**CONSOL ENERGY™****Consolidation Coal Company**P.O. Box 566
Sesser, IL 62884
(618) 625-2041

Pamela Grubaugh-Littig
Utah Division of Oil, Gas and Mining
Coal Program
1594 West North Temple, Suite 1210
Box 145801
Salt Lake City, Utah 84114-5801
2/15/2005Re: Emery Deep Mine Permit C/015/015
Amendment to MRP to revise partial pillar splitting plan (certification pages)

Title: Updated Pillar Split Plan

Update the MRP to match the MSHA approved Pillar Splitting Plan (Certification pages)

**Figure 1: Partial Extraction with Timbers for Supplemental Support
Mirror image applies**

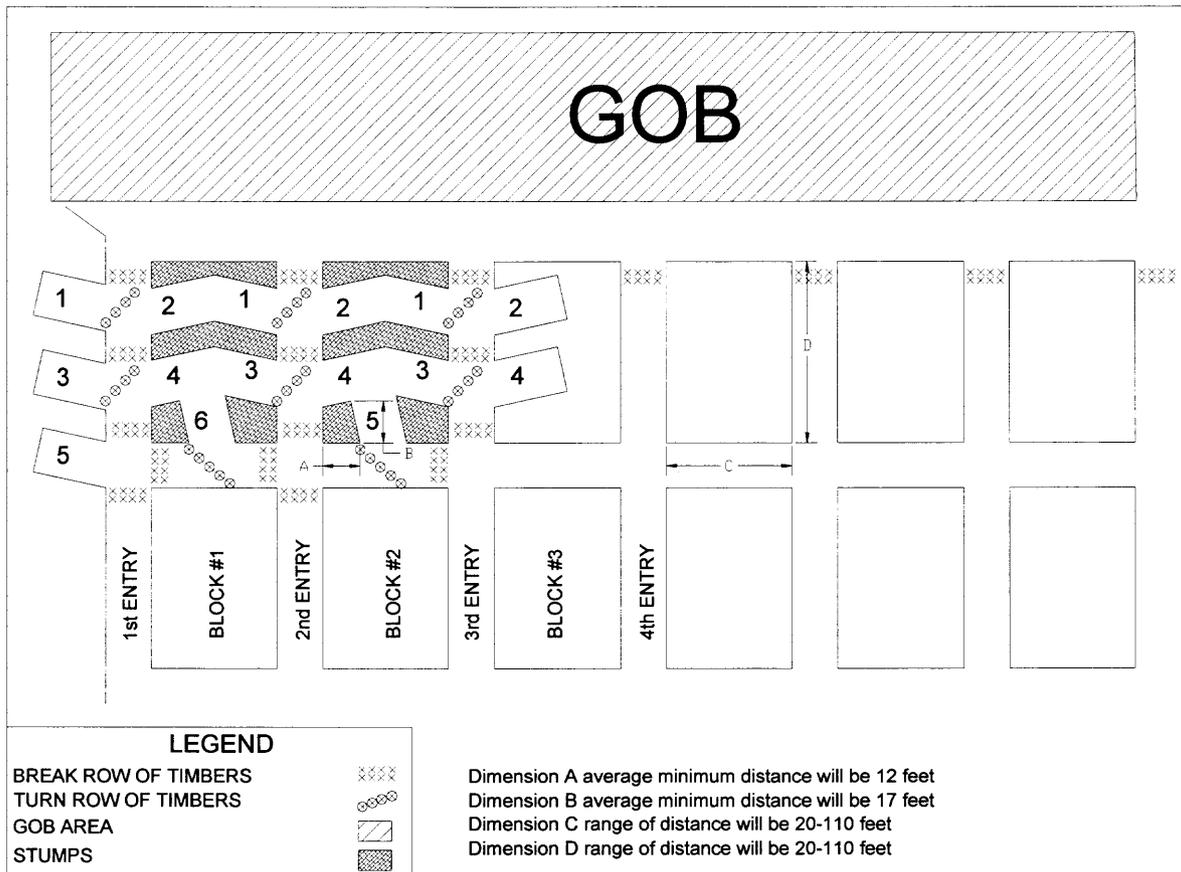
**PILLAR SPLIT PLAN SITE SPECIFIC FOR
1ST AND 2ND SOUTH**

1. A breaker row may consist of either:
 - a) two MRS units, or
 - b) two row of posts on a maximum spacing of four feet (4'), or
 - c) two cribs

1st and 2nd South Pillar Plan	
DRAWN BY: S McCourt SCALE: Not to Scale DATE: 01/14/05	Figure V-1 CH V Page 28d REV. ---

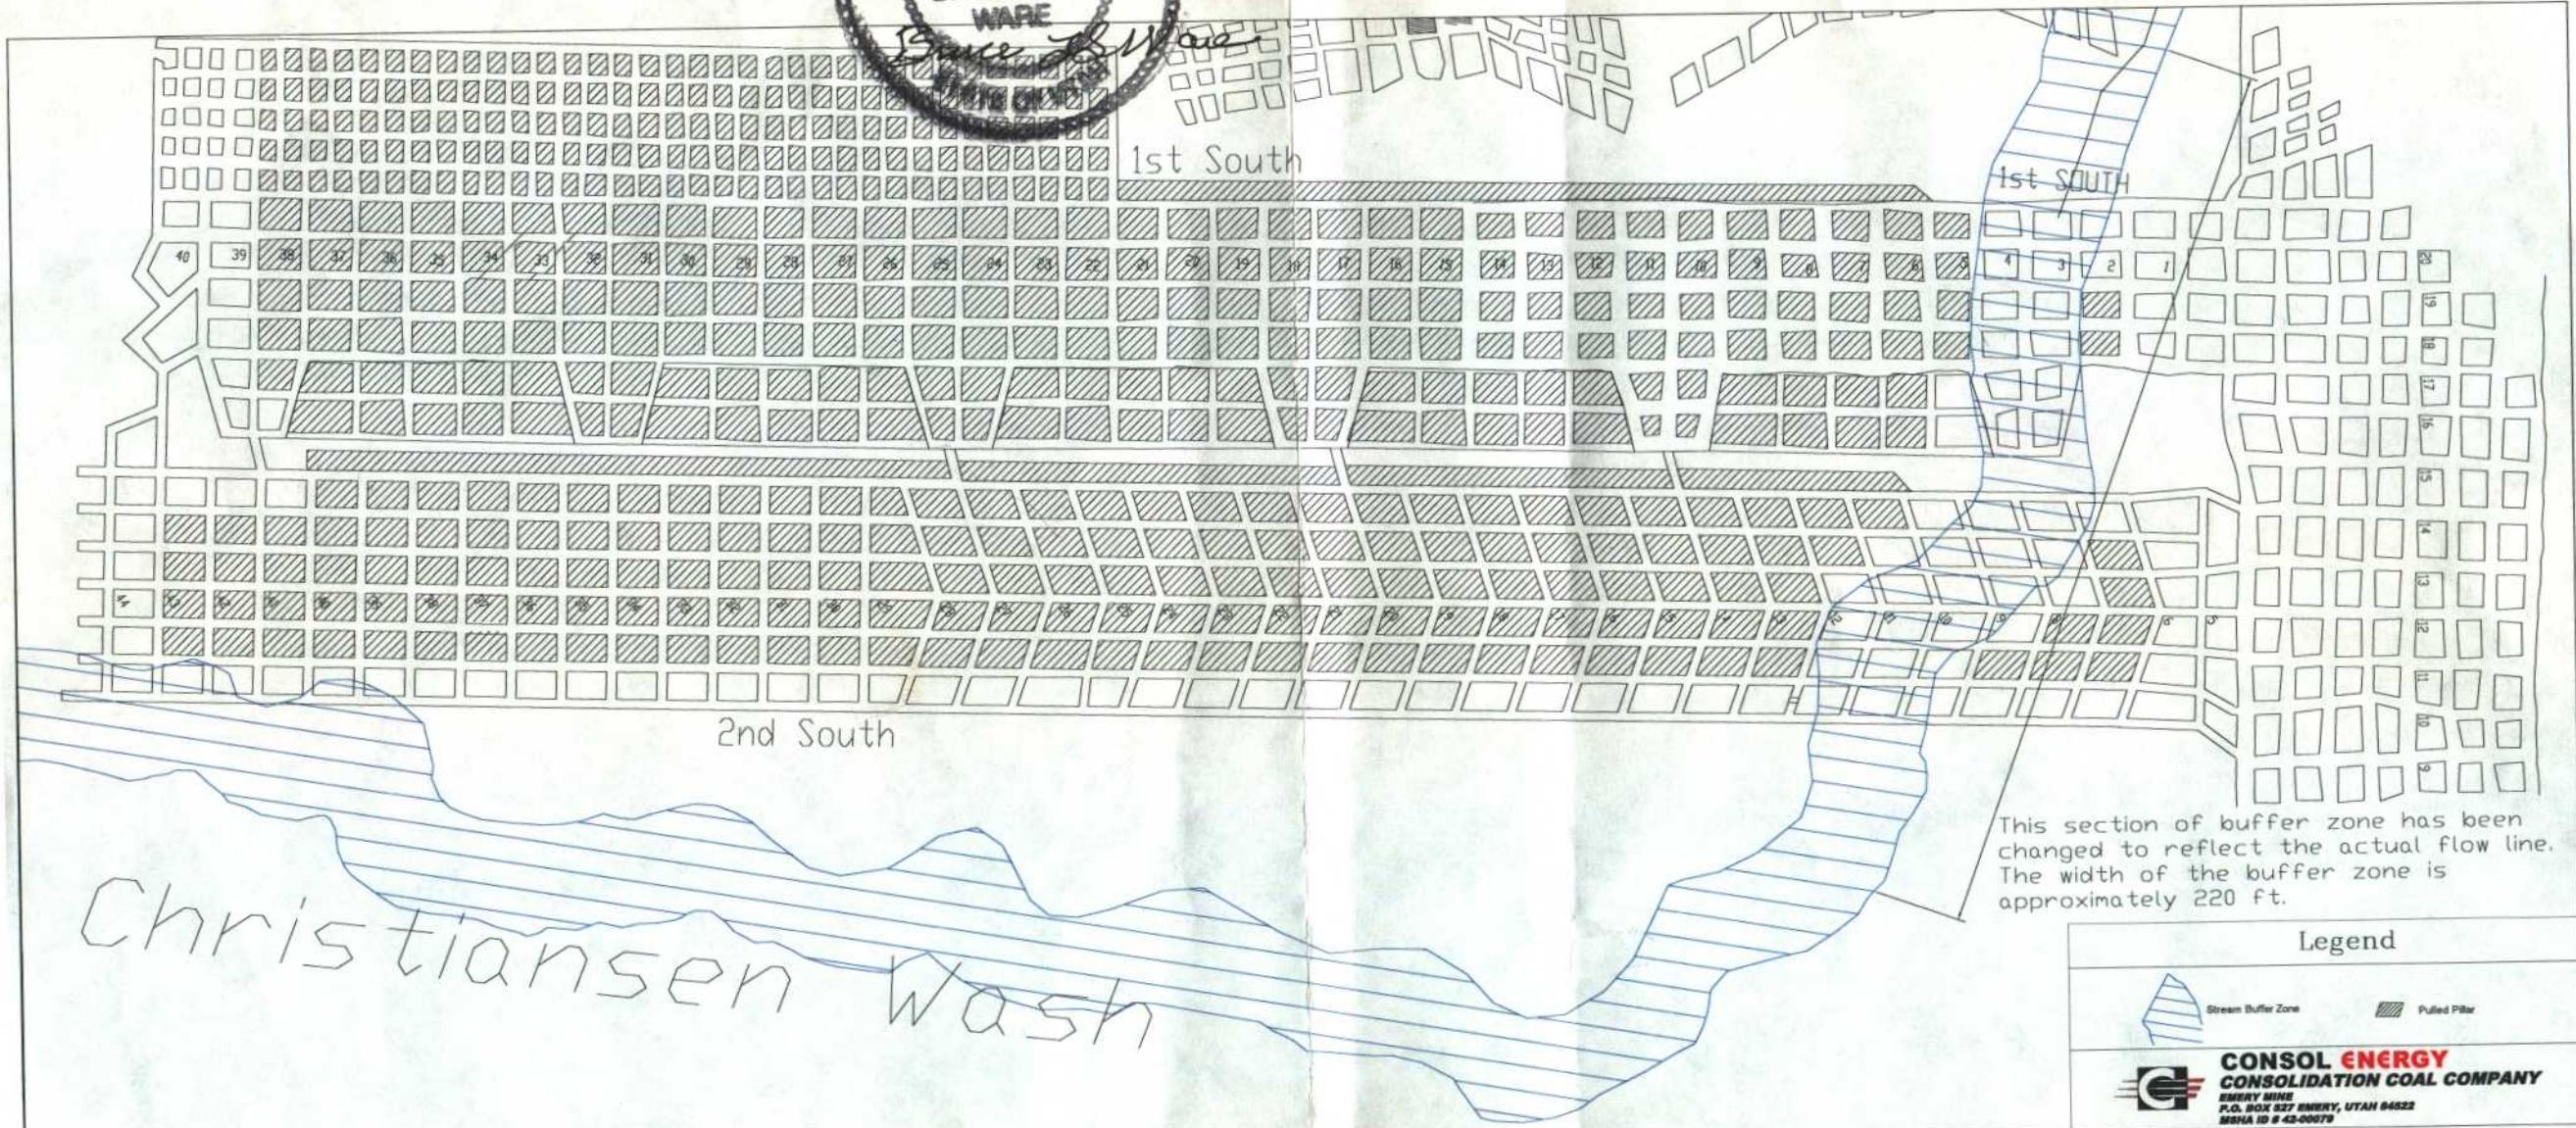
This section of buffer zone has been changed to reflect the actual flow line. The width of the buffer zone is approximately 220 ft.

Notes:
 The maximum depth (roof to surface) over any pillar being pulled will be approximately 135 feet.
 This figure is only a projection and the actual pillars that will be split will be determined by the approved MSHA plan and pillar design calculations.
